29 March 1976

From: CENTRAL DEFECT AUTHORITY  
Procurement Executive, Ministry of Defence, St Giles Court, St Giles Hill, London WC2E 9JF  
Tel No: 01-632-6209

- A SI/HUNTER/126A  
(SUPERSEDING STI/HUNTER/397)  
TAIL UNIT: FIN: REAR ATTACHMENT FITTINGS: CRACKING
- B 1 Hunter, All Marks  
2 Hunter Fins Pt No D183036 (Reference 26FX/67); D207585 (Reference 26FX/7985); D223171 (Reference 26FX/9338); F222286; D232192; D281363; and D311880 held as spare or in store.

S1/HUNTER/126A PART  
ALTERATION OF SIDE  
FAIRINGS ON TAIL UNI

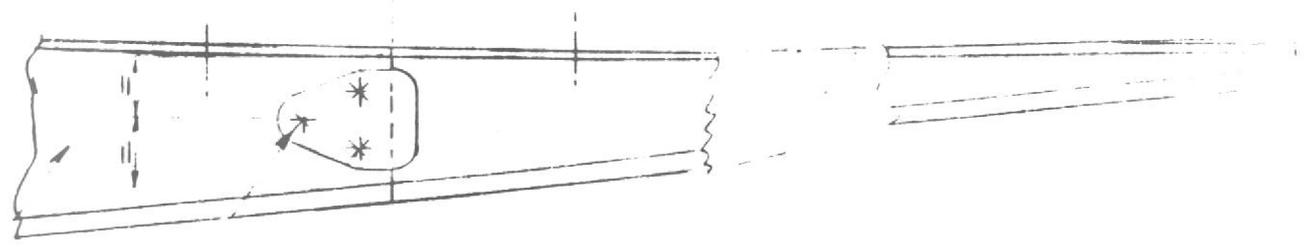
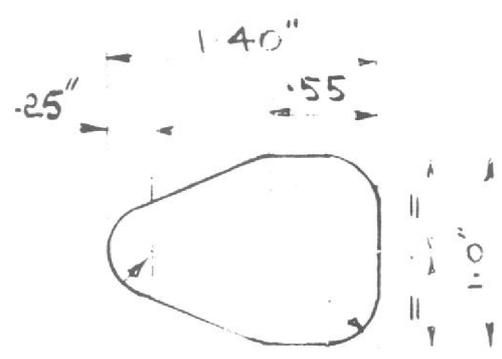
CUT LINE  
25" TYPICAL

7.3" TO 7.5" APPROX TO MATCH  
EXISTING CUT-OUT IN ATTACH  
FLANGE.

CUT LINE 11.50"

RIVETS AS 164-405 REF 282/95447  
DRILL HOLES 3.25 m.m DIA. & CSK ITEM 2 FAIRING  
20° x .042" RIVETS FINISHED FLUSH BOTH SIDES.

DRILL 3 HOLES 3.25 m.m. DIA.
